METROPOLITAN GOVERNMENT OF NASHVILLE AND DAVIDSON COUNTY

STAFF RECOMMENDATION
104 Fifth Avenue South
July 18, 2012

Application: New construction of rooftop additions
District: Broadway Historic Preservation Zoning Overlay
Council District: 06
Map and Parcel Number: 09306311200
Applicant: Mark Bixler, Manuel Zeitlin Architects
Project Lead: Robin Zeigler, robin.zeigler@nashville.gov

1971

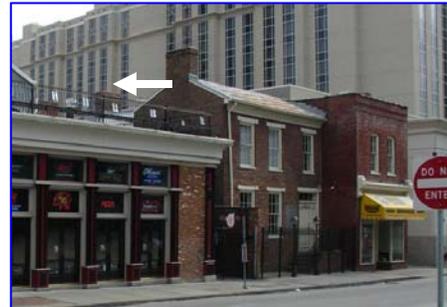
The exact configuration and design of the original storefront is unknown as the earliest photograph found, at this time, is from 1971 and shows the windows enclosed. The applicant proposes a simple storefront design that is typical of this style and age of commercial building, as required of Section C.3.1 of the Broadway design guidelines.

The new storefront will be wood with a wood bulkhead, clear-glass windows and transoms and a recessed entry. As early as 1971, the recessed entry was centered. The applicant proposes that the new recessed entry be off-center. Because the original configuration is unknown and because an off-center entrance is found historically, staff finds this alteration to meet Section II.A of the design guidelines.

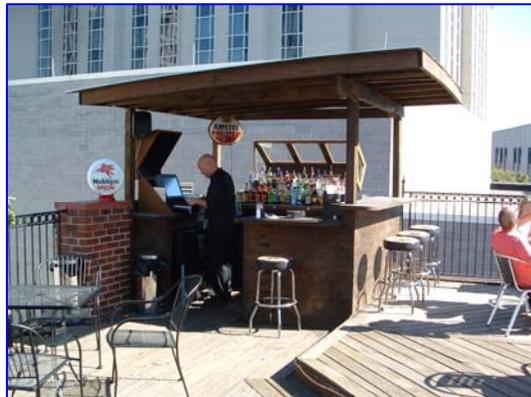
This portion was added without permits and will be removed.

This stairwell (above), railing (below left) and bar (below right), constructed without permits by the prior owner, will be removed.

ROOF TERRACE
 PLAN
 MHC FILING
 JULY 4, 2012

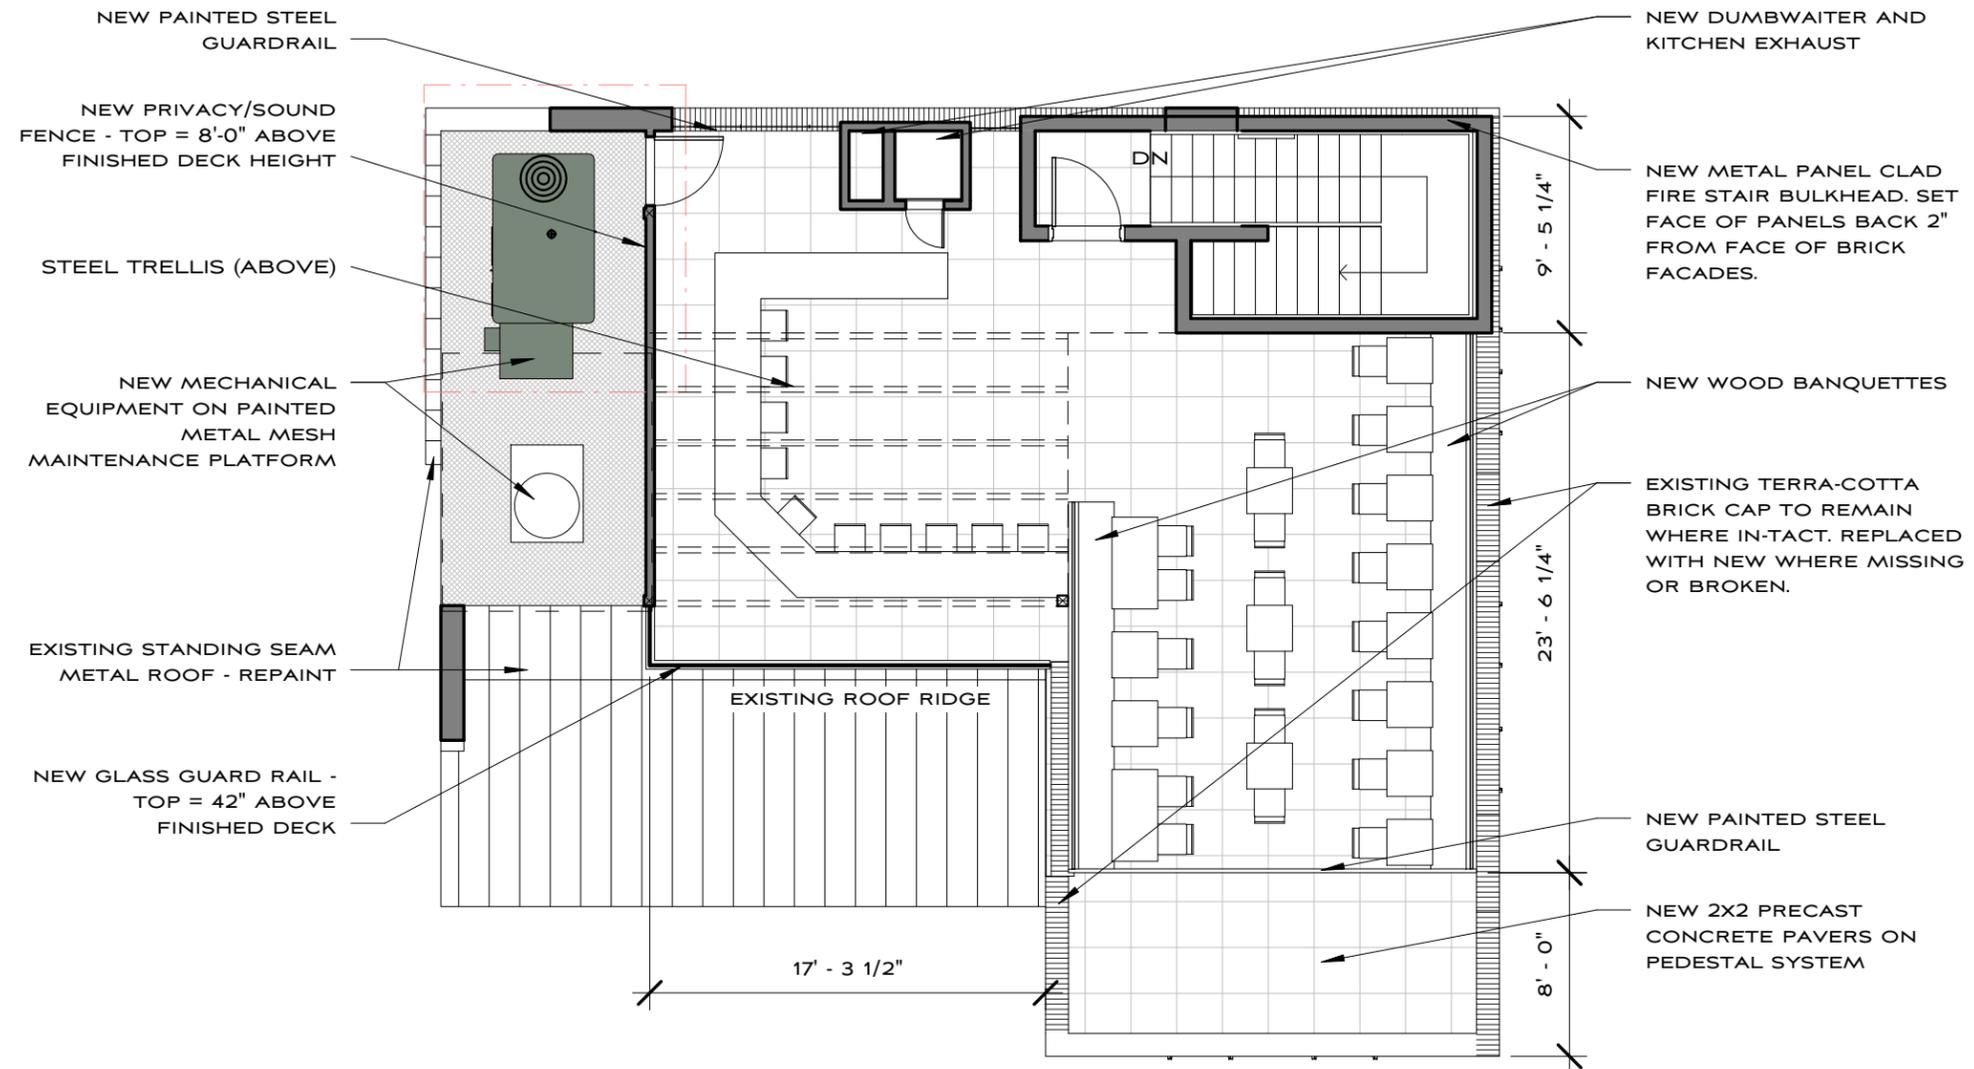
On the North building, the closest portion of the addition to the front is a glass railing, set just behind the ridge and rising approximately one and one-half feet (1.5') above the ridge line. Approximately two and one-half feet beyond that is the start of an open steel trellis that rises approximately eight feet (8') above the ridge. In addition, mechanicals will rise approximately four feet above the ridge but are set back approximately six feet (6') from the ridge. A metal wall to shield the view and noise of the mechanicals from patrons will rise perpendicular to the ridge and approximately seven feet (7') above the ridge. Because of the open nature of all elements and the narrow depth of the building, staff finds the rooftop additions on the North building to meet VI.H.2.

On the South building, the tallest part of the one-story proposed rooftop addition will rise approximately nine feet (9') above the parapet wall. The enclosed portion will sit back from the front wall by thirty-two feet (32'), more than meeting the design guideline's requirement of a thirty foot (30') setback; however, overall, the addition begins only eight feet (8') back from the front wall. The portion of the addition closest to the front is an open railing that only rises one foot (1') above the parapet wall. Staff recommends sitting this wall back from the ridge a total of two feet (2') to assure that it is minimally visible, if at all. Due to the shallow depth of the building and the applicant's ability to place the tallest and bulkiest portions of the addition to the back, staff finds that the project meets section VI.H. of the design guidelines.

1. the glass wall sit back two feet (2');
2. the storefront not have what appears as stacked transoms;
3. the brick not be sandblasted or cleaned with abrasive means;
4. a flexible mortar, made from mixing hydrated lime cement and natural sand, is used where necessary; and
5. mortar matching the existing mortar in width, depth, color, raking profile, composition, and texture is used, where repointing is necessary.
